ALASKA DEPARTMENT OF ENVIRONMENTAL CONSERVATION
Air Permits Program

BEST AVAILABLE CONTROL TECHNOLOGY DETERMINATION
for
Chena Power Plant
Aurora Energy, LLC.

Prepared by: Aaron Simpson
Supervisor: James R. Plosay
Date: May 10, 2019

**ADEC Request for Additional Information
Aurora Energy LLC. – Chena Power Plant
BACT Analysis Review
Environmental Resources Management Report, March 2017**

Figure 1. Aerial View of Chena Power Plant.

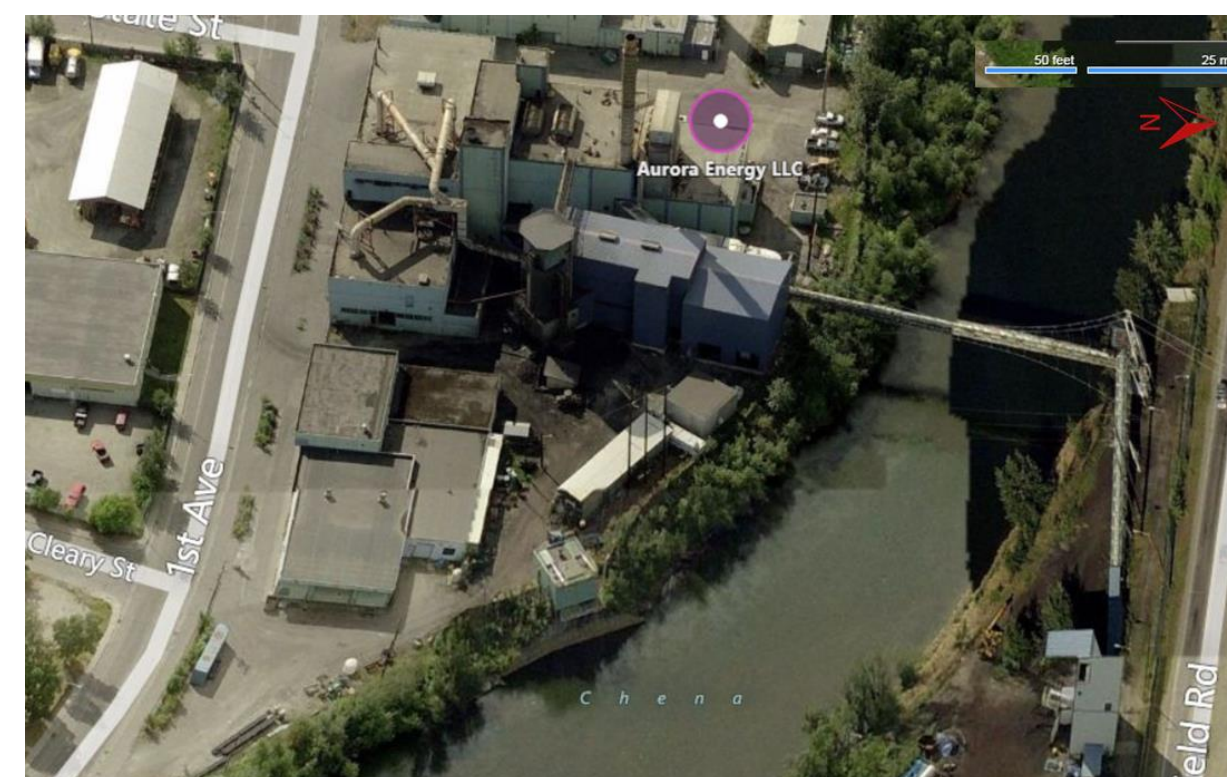
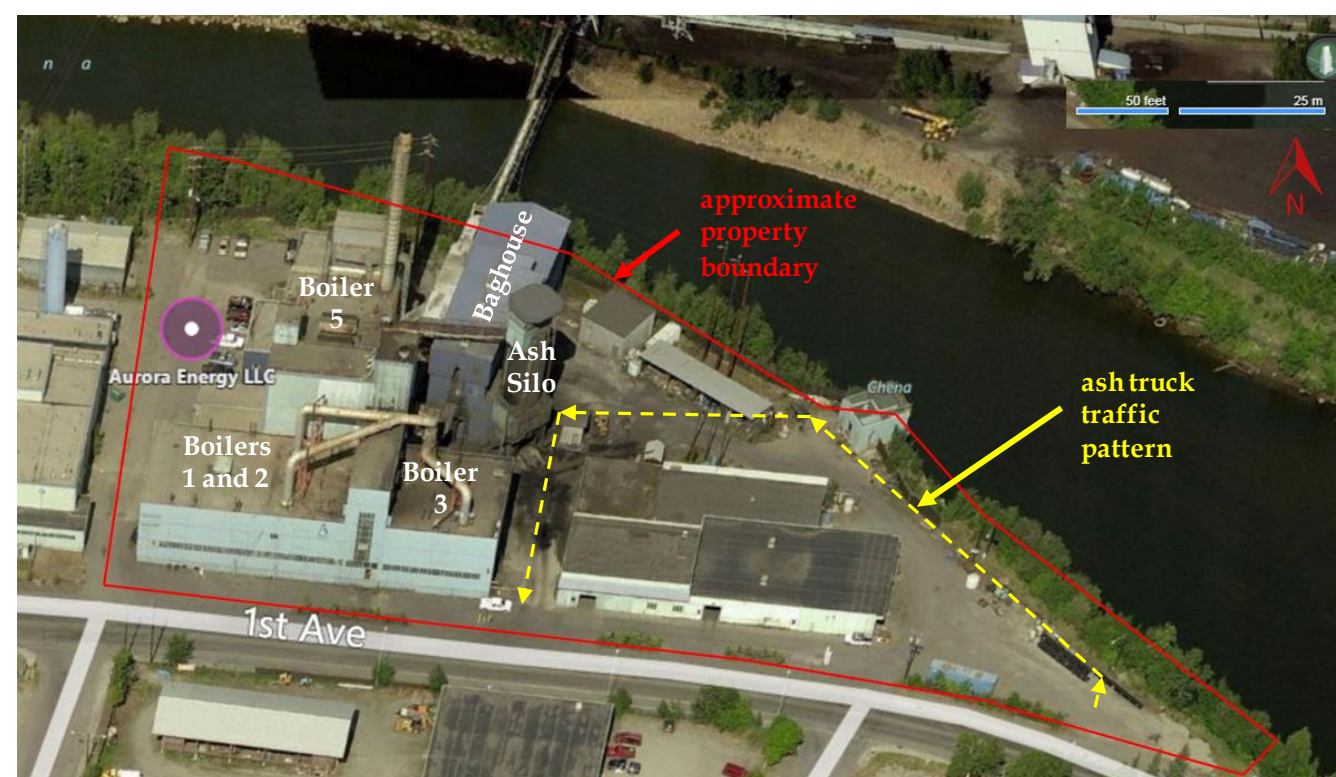
6. Space Constraints – In order to establish a control technology as not technically feasible due to space constraints or other retrofit considerations, detailed site specific information must be submitted in order to establish the basis for such a determination, including detailed drawings, site plans and other information to substantiate the claim.

Much of the equipment needed for an SDA system would be large items that occupy a substantial footprint. As can be seen in Figure 1, very little unused space exists at the facility. No space exists for an enclosed spray tower, and therefore a tower would need to be sited outdoors. No space exists between the combined boiler ducts and the fabric filter (as seen in Figure 1) to insert a spray tower. Because all of these duct runs are located

outdoors, maintaining the flue gas temperatures needed for the reaction and preventing moisture in the fabric filter will be expensive and difficult. Finally, as can be visualized by looking at Figure 1, the site does not have enough unused area to accommodate a dry material receiving operation and slurry preparation area. There is a likelihood that material receiving would have to occur on the north side of the Chena River. This would necessitate another river crossing which adds another layer of complexity to the process. Ultimately, the spatial considerations for the equipment would require a building to house the technology and heat to maintain the temperatures needed for the application. The parasitic load from electrical consumption and heating for the application would be substantial; at the least greater than 2.5% of current net generation.

Factors Influencing NSR – The congested site layout will potentially adversely impact the amount of sorbent needed (i.e., NSR) to achieve reasonable reductions using DSI. Figure 1 previously showed the arrangement of flue gas duct work for Boiler 1, 2, and 3. Although not visible in Figure 1, these three duct systems combine with the flue gas duct work for Boiler 5 just prior to entering the fabric filter. If a single sorbent injection location is specified, this location would provide a short mixing zone with a low residence time prior to the fabric filter. Approximately 10 ft of duct is available between the location where the flue gas ducts converge and the combined gas enters the fabric filter. Gas velocities between 55 ft per second (ft/s) and 75 ft/s exist at this location, indicating that the sorbent and flue gas would be afforded only between 0.1 and 0.2 seconds of mixing/residence time prior to entering the fabric filter housing. The GVEA Healy plant's Unit #1 (305 MMBtu/hr boiler) has a 100-ft run prior to the baghouse from the injection point. Assuming GVEA maintains similar duct velocity as Chena, the GVEA DSI system operates with a reaction time of 1 or 2 seconds of mixing prior to entering the fabric filter housing. The mixing zone and residence time at the Chena plant would be very short (10 times less) in comparison and will potentially require additional sorbent be injected to achieve any sort of SO₂ removal. This will, in turn, reduce the cost effectiveness of a DSI system (i.e., increase the operating cost and reduce the removal rate).
